CITY OF SACRAMENTO

2. Tentative Map (P89-138)

North of West El Camino Avenue, Between Gateway Oaks Drive and

A RESOLUTION ADOPTING FINDINGS OF FACT AND APPROVING A TENTATIVE MAP FOR PROPERTY LOCATED NORTH OF WEST EL CAMINO AVENUE. BETWEEN GATEWAY OAKS DRIVE AND NATOMAS MAIN DRAINAGE CANAL

UNIT PLAN

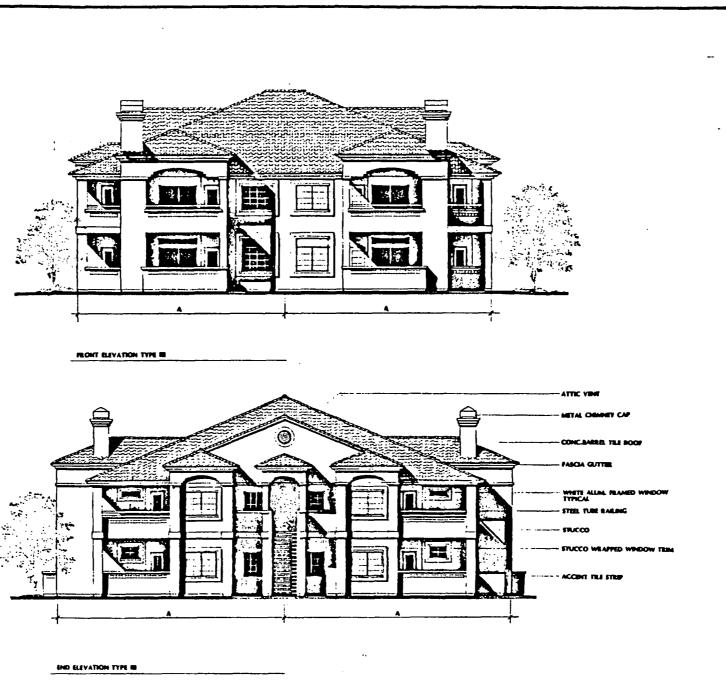
Staff has agreed with the applicant to map the project for condominium units and is requiring that a minimum of $\frac{14}{4}$ 7 units in the entire condo/apartment project be handicap accessible. The State requires that all ground level apartment units be handicap adaptable, whereas, condominium projects do not require handicap adaptable units. (staff amended)

Staff is recommending that at least 14 units (3% of the apartment and condominium projects) be handicap accessible. The 14 units are based on the total number of units for both the condominium and apartment project times three percent (456 total units x 3% = 14 units). The applicant has provided the city with information from the State of Rehabilitation indicating that the percentage of non-ambulatory handicap population in Sacramento is approximately one percent (1% x 477 dwelling units = 5 DU). The applicant is, however, providing 7 has informed staff that the handicap accessible units will be provided on the apartment project (staff amended)

- 6. A minimum of ±4 7 units shall be made handleap accessible and conform to the Uniform Building Code. (staff amended)
- 7. Several of the enclosed garages shall be recessed away from the private streets to allow landscaping to extend past the face of the garages.

DRAWNG TITLE EXTERIOR ELEVATIONS

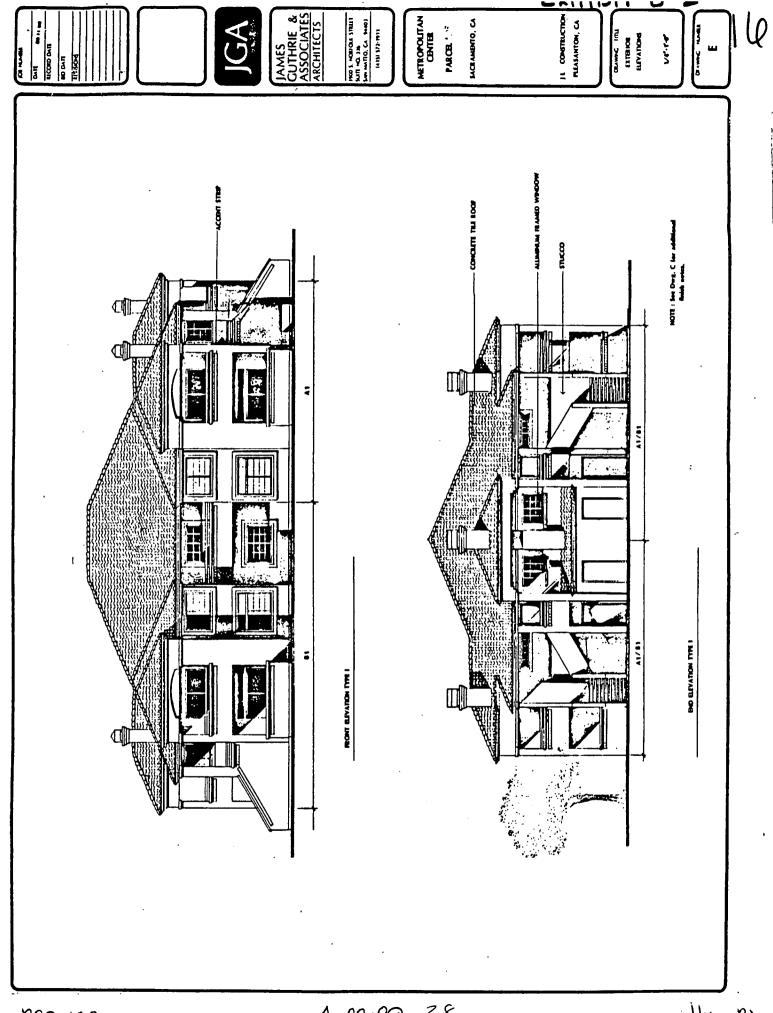
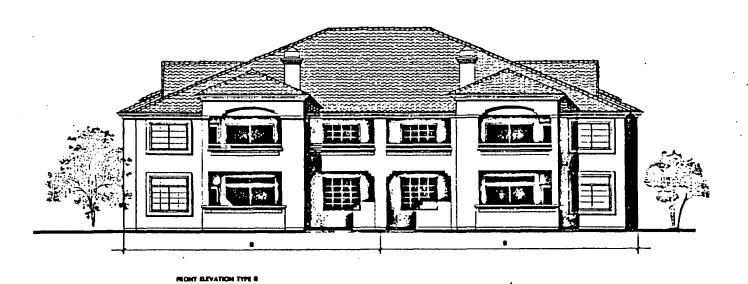
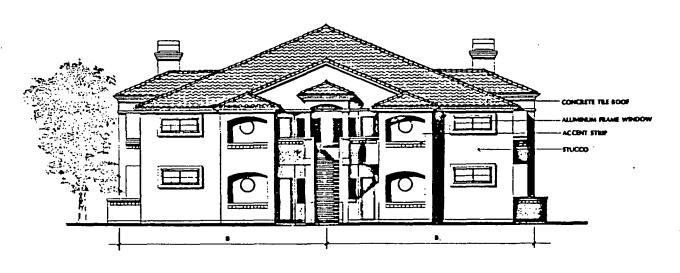
The exterior building material for the apartments consist of stucco plaster and the roof material is concrete tile. The building exterior color will be dusty rose, coral and off white colors with a light green trim. Staff recommends that the applicant vary the main body color. The elevations indicate white aluminum frame windows and an accent tile strip on some of the buildings. Staff recommends that all arches on the buildings be centered between column faces and the stepped spring line shall be symmetrical at each column.

- A photo or drawing of the proposed wall along the perimeter of the subject site shall be submitted to staff for review and approval prior to issuance of building permits.
- All trash enclosures shall comply with the City's Trash Enclosure Ordinance.
- 3. Mechanical equipment (including public utility boxes) shall be attractively screened.
- 4. The building shall contain at least three body colors to lesson potential monotony.

- 8. All arches on the buildings shall be centered between column faces and the stepped spring line shall be symmetrical at each column or other alternatives subject to staff approval. (staff amended)
